Access Compliance Report Public Rights-of-Way (Curb Ramps)

Main Street: THERESA_AVE Cross Street: THISTLE_RD Location: S

ADA ID: RPRK210924173848 Ramp Type: Type 6 - Directional 1 Initial Pass/Fail: Fail Overall Compliance: No Severity Score: 2

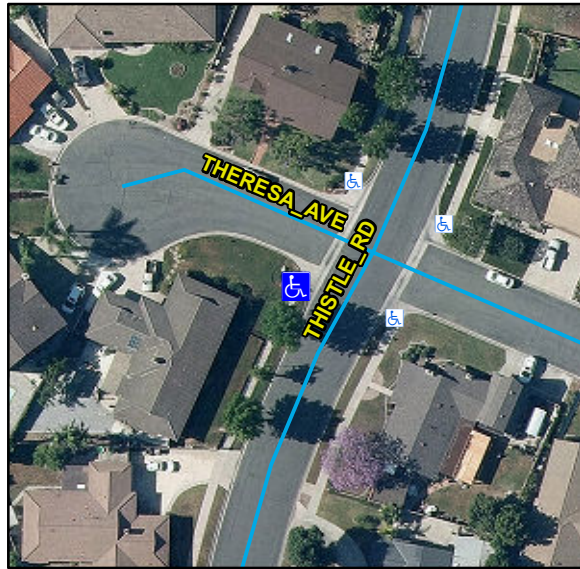
Compliance	Description	Data	Compliance	Description	Data
N/A	Ramp Length (in)	92	N/A	Flare Type LT	
Yes	Ramp Width (in)	60			N/A
Yes	Ramp Run Slope (%)	5.7	N/A	Flare Slope LT (%)	N/A
No	Ramp Cross Slope (%)	4	N/A	Flare Traversable LT	N/A
N/A	Grade Break	N/A	N/A	Flare Type RT	
N/A	Grade Break Slope (%)	N/A			N/A
N/A	Grade Break Cross Slope (%)	N/A	N/A	Flare Slope RT (%)	N/A
	Addl Para Ramp Left?	No	N/A	Flare Traversable RT	N/A
	Addl Para Ramp Right?	No	N/A	DWS Provided	N/A
N/A	Landing Present	N/A	N/A	DWS Contrast	N/A
N/A	Landing Length (in)	N/A	N/A	DWS Length (in)	N/A
N/A	Landing Width (in)	N/A	N/A	DWS Full Width	N/A
N/A	Landing Run Slope (%)	N/A		DWS Offset Type	N/A
N/A	Landing Cross Slope (%)	N/A	N/A	DWS Left Offset (in)	N/A
N/A	Landing Movement Obstructed?	N/A	N/A	DWS Right Offset (in)	N/A
	Landing Movement Type	N/A			
N/A	Landing Shared	N/A			
N/A	Marked Crosswalk 1	No	N/A	Clear Space	Yes
	Crossing 1 Direction	E	N/A	Clear Space To Crosswalk (in)	N/A

Remove & Replace Curb Ramp With Two New Directional Ramps or Equivalent.

R304.5.3, STD 1115
